ADDENDUM NO. 1 TO CONTRACT DOCUMENTS

Project: MacDonald Downs Pump Station H&S Project No. 30906-006

Owner: City of Havelock

Date: 10/10/2017

Detail 1511502 Yard Hydrant

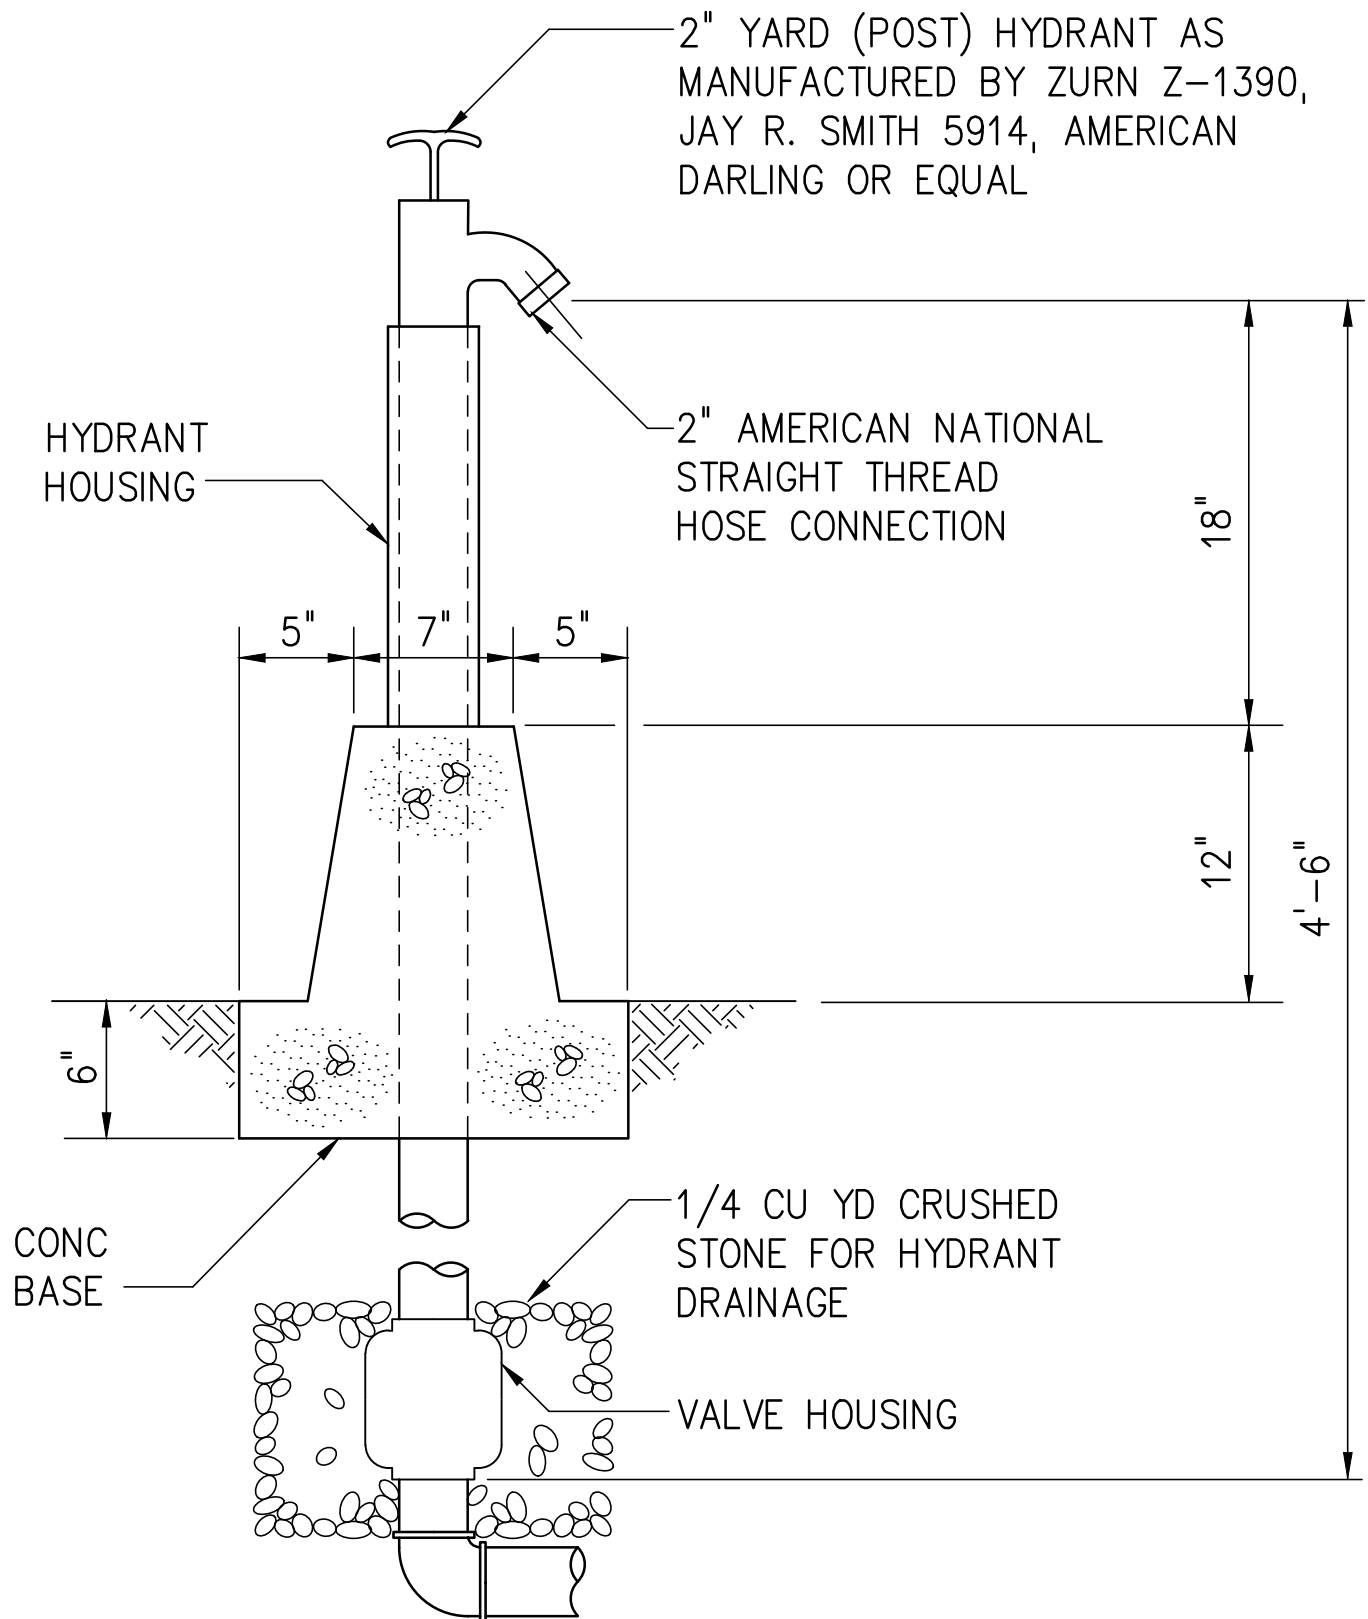
| <u>Item 1.</u> Drawing C-1 | Add the following NOTE:

"3. Install a 2 inch water service connection, including a meter and backflow preventer, from the existing 10 inch PVC water line in the US70 right of way to the new pump station site. Meter and backflow preventer shall be to City of Havelock standards. Install approximately 700 lf of 2 inch Schedule 40 PVC water line and fittings in the existing force main easement along the property line. PVC pipe shall conform to ASTM D 1785 and fittings shall conform to ASTM D2466. Terminate the water service with a yard hydrant per detail 1511502. Owner shall designate location of the yard hydrant inside the new pump station fence." |

| <u>Item 8.</u> Drawing D-03 | Add attached Yard Hydrant Detail 1511502 |
